## **PARTS BULLETIN No. 2-20**

### **Subject: Wing Folding Cylinder Upgrade Kits**

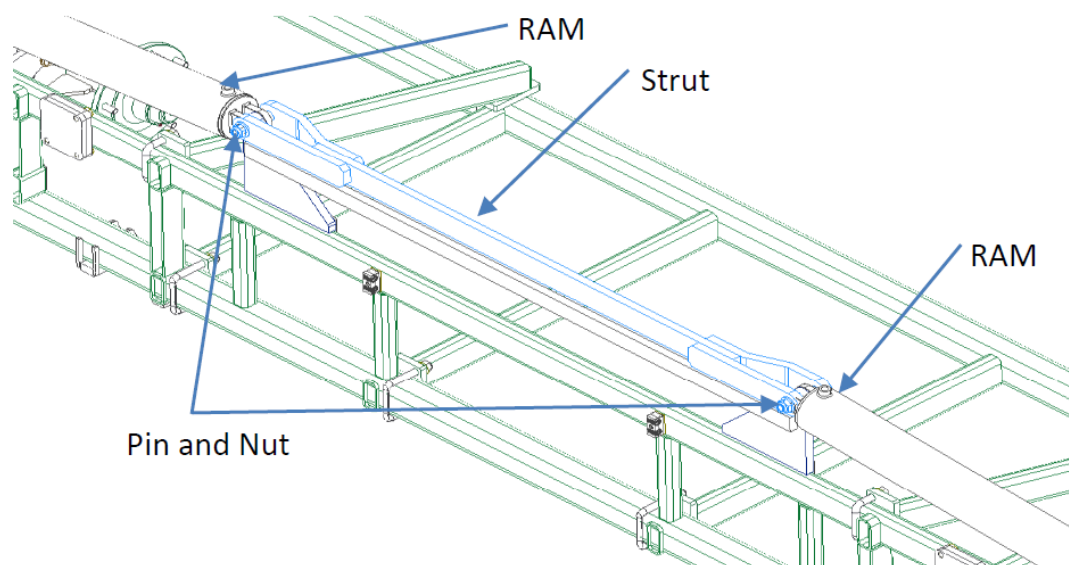
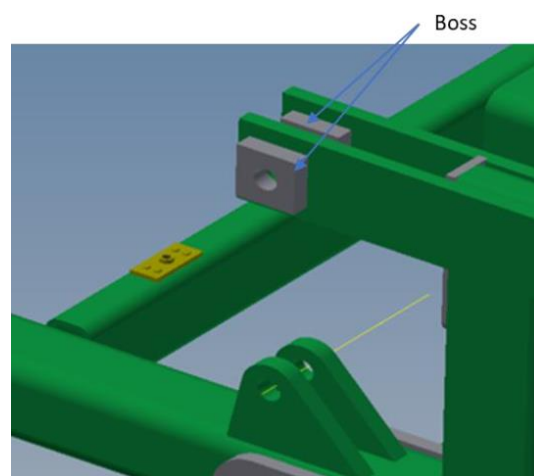
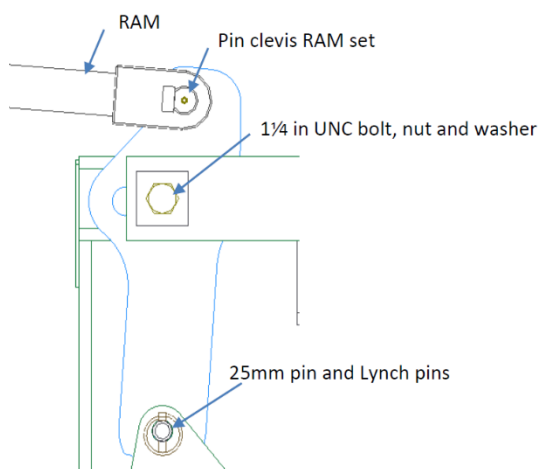
Since late 2009, all Ausplow DBS have been manufactured with a 1 ¼" pin on all the wing folding cylinders. Previous to this, Ausplow used a 1" wing fold pin. The change was due to Ausplow's hydraulic cylinder supplier no longer manufacturing or supporting wing fold cylinders that take a 1" pin.

This change by our supplier also means that all larger model DBS machines (**59-260E, 60-260E, 64-260E, 70-260E, 55-300E, 59-300E, 61-300E & 60-300T** manufactured prior to serial number DBS833), which currently have the 1" wing fold pin and need a replacement wing fold hydraulic cylinder, must upgrade the wing fold area to accept the 1 ¼" pins. **Ausplow strongly recommends not using a 1" pin with bushes or drilling out 1" holes to accept 1 ¼" pins on the models listed above.**

The Wing Fold Upgrade Kits consist of two new 1.25" pin 5.5" or 6" Wing Fold Cylinders, two Wing Lift Arms, Strut Kit, Frame Bosses, Pin and Bolts.

Two bosses are to be fully welded to the frame if not already fitted.

The lug which secures the base of the wing fold cylinder and the frame bosses will require drilling out to 32mm using a mag drill. The new wing fold cylinders, wing lift arms (fish plates) and strut kit are then fitted in accordance with the fitting instructions supplied with each kit.
